भारत सरकार - रेल मंत्रालय
अनुसंधान अभिकल्प और मानक संगठन
लखनऊ - 226 011
Government of India - Ministry of Railways
Research, Designs & Standards Organization,
LUCKNOW - 226 011

MODIFICATION SHEET No.
RDSO/2011/EL/MS/0396 (Rev. '0') Dated: 17.10.2011

Modification in Brake hanger mounting brackets (Holder and Support) of WAP-7/WAG-9 Electric locomotives to prevent crack/ breakage of bracket.

Procedure for replacement of Mounting Bracket and holder to bogie frame:

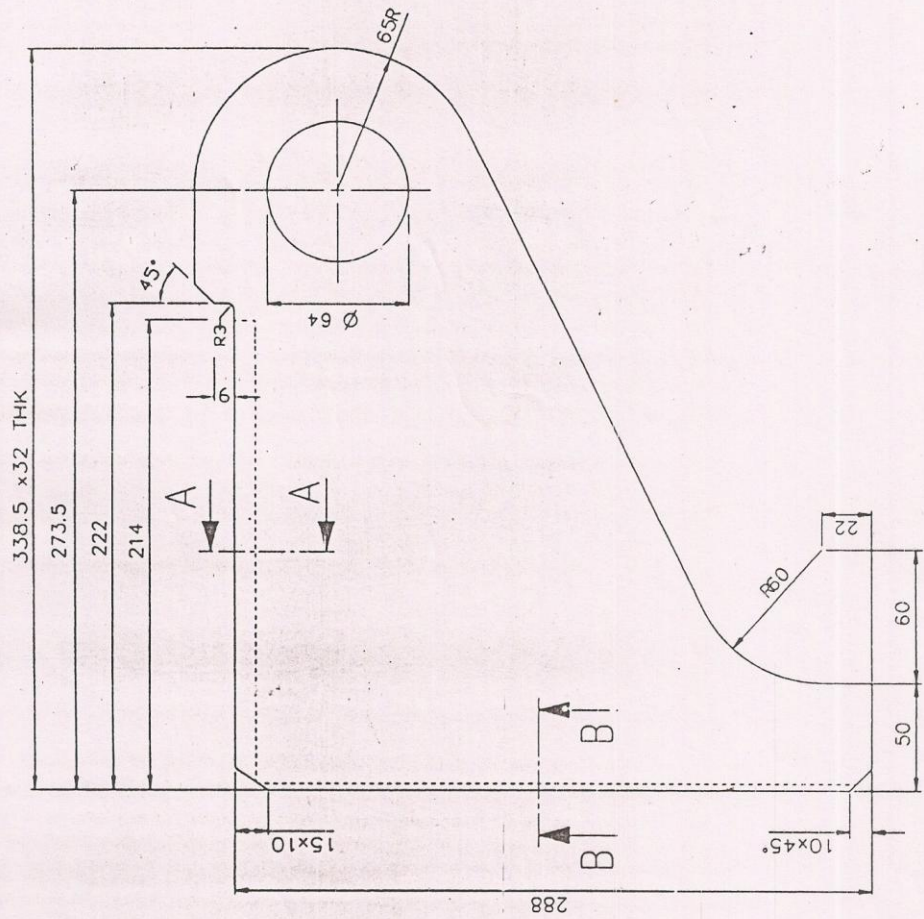
- b) Remove brake hanger mounting brackets and plate (Drg No. 1209-01.412-139) by oxy-cutting cleanly. Care should be taken during cutting operation to prevent formation of notches and excess removal of material. There should not be any mark or traces of foreign material on the bogie frame from where brackets are removed. Also the grinding should be done at all the cut locations smoothly for removal of stress raiser point.

- c) Bogie shall be examined after this for smooth finish and inspected for any cracks/abnormality at all the locations by DPT.
- d) The brackets for various locations shall be manufactured as per RDSO Drawing No. SKEL-4862 and SKEL-4863 observing improvements suggested in para 5.0 (iii) above.

- g) The modified bracket and plate shall be welded at appropriate location by MIG/MAG welding. Use of proper jig to locate the bracket in position shall be used. The welding procedure and inspection/testing of weld quality shall be done as below:-

1. The weld area shall be preheated to about 150⁰ C by using oxy-acetylene torch.
2. Metal Active Gas (MAG) welding process using CO₂/(Argon+ 1-5% O₂) shielding gas shall be used. MIG/MAG welding filler wires approved under IRS class-III as per IRS M-46 of size 1.2 mm (preferably) should be used.
3. Welder employed for welding of bogie frame shall have a high standard of workmanship and shall be qualified to IS: 817/IS:7310.
4. A Weld joints shall have uniform beading and smooth change over from weld deposit to parent metal and thorough fusion between adjacent layers of weld metal and between weld metal and parent metal.

5. Adequate measures shall be taken in the process to avoid distortion during welding.
 6. Weld joints shall be free from cracks, craters, undercuts, overlaps, porosity, inclusions, blow-holes etc.
 7. In butt welded area, no extra runs are needed than required. Only stress raiser if any shall than be ground off by to and fro motion of grinder to eliminate stress raisers.
 8. The fillet weld profile shall be flat to concave with concavity within the stipulated limits depending upon fillet size so that smooth transition occurs at the toe of weld maintaining correct size of the welds.
 9. For welding of circular area, circumferential welding sequence shall be followed.
 10. The quality of entire weld length shall be checked by Dye Penetrant test by the Quality cell and record to be kept.
- h) Bogie frame shall be coated with one coat of anti-corrosive paint in order to prevent rusting.
